Date: January 24, 2007
To: Surface Transportation Board
Case Control Unit
Washington DC 20423
Attention: Rini Ghosh
STB Docket No. FD 34284

- A. Supplemental Draft Environment Impact Statement
Finance Document No 34284
Southwest Gulf Railroad Company
Construction and Operation Exemption
Medina County, Texas
 - 1. Volume I – Executive Summary – Chapter 6 and appendices A & B
 - 2. Volume II – Appendices C – F
- B. Figure 5.1 Resource numbers & Survey Area Boundaries
Quihi Vicinity, Medina, Texas

ATTACHMENT A

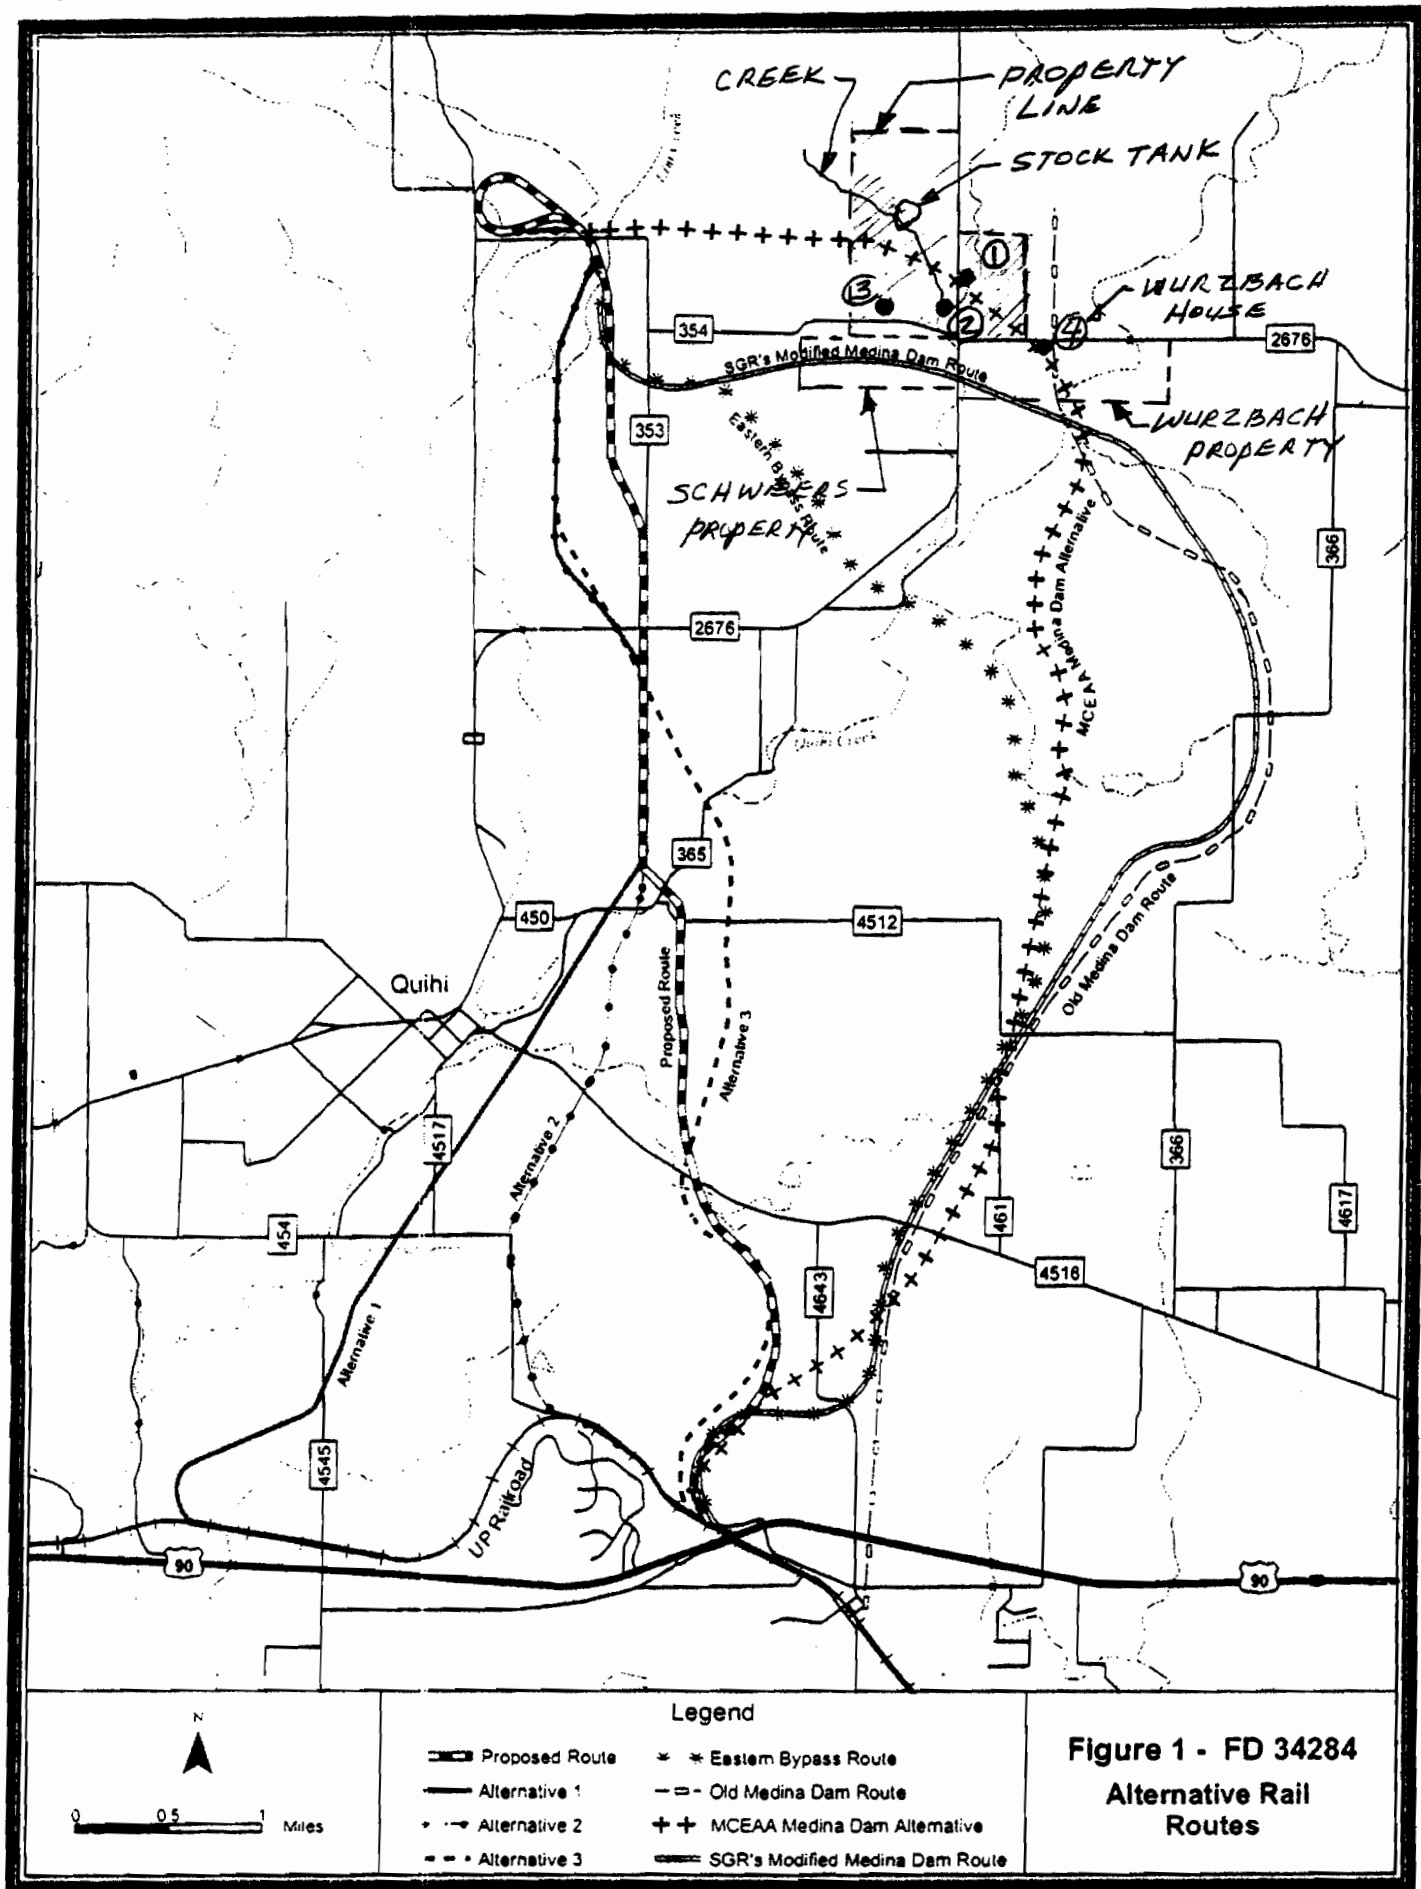
I wanted to stress to you impact that the purposed railroad will have on our family land. This land was bought by my Great Grandfather in 1937. My grandparents, Earl & Irene Balzen lived there all their married life. My dad, Henry Earl Balzen grew up here and now my son Zachary Earl is growing up here. We have three generations living here. My grandparents worked hard to keep this land through everything the life sent their way. My son is the fourth generation to live here and take pride in this land. Now, we are fighting to keep this railroad from destroying it. I have enclosed a map to show you our houses. My parents' home is #1, the homestead is #2 and my home is #3. As you can see by the map, the particular route identified as the MCEAA Medina Dam Alternative Proposed Route in references A1 & A2 passes almost directly over my parents' house, which is located on County Road 265 just north of FM 2676 (#340 of ref. B). The proposed route passes completely through all of our property (see Attachment A). The shaded area shows the location of our property. The route passes between my parents' house and the homestead.

- 1. The route crosses two major roadways within approximately one half mile of each other (FM2676 & CR 265). Although CR 265 is a gravel country road it

2. The route runs between houses #1 & #2, which are only 300 yards apart.
3. County Road 265 is an "open range" road which means our cattle roam free across and on the road. Our cattle pens and barn are all at house #2 of Attachment A.
4. The route crosses the creek at the point of greatest elevation change from the creek to the adjacent hill.
5. Another creek (as shown on Attachment A) west of CR265 on my property, not shown on your maps, will also have to be crossed.

I request that you consider the following comments and /or suggestions for a combination MCEAA Medina Dam Alternative and SGR's Modified Medina Dam Route. The MCEAA route to be used until it intersects SGR's Modified Dam Route just south of FM 2676. This proposal offers several advantages.

1. There are not any residences in the direct path of the rail route as with the Proposed MCEAA route and the Eastern Bypass Route where it crosses FM 2676.
2. CR 265 does not have to be crossed.
3. The creek west of CR 265 noted on Attachment A does not have to be crossed because it merges with the other creek at house #75.
4. SGR's Modified Route passes through property owned by Mr. Wurzbach and Mr. Schweers (see noted area of Attachment A) who will financially benefit from the quarry because they both own property at the quarry site. The rail right-of-way should be a way for them to demonstrate support for their financial benefit of the quarry operation and to avoid major impact on their neighbors.
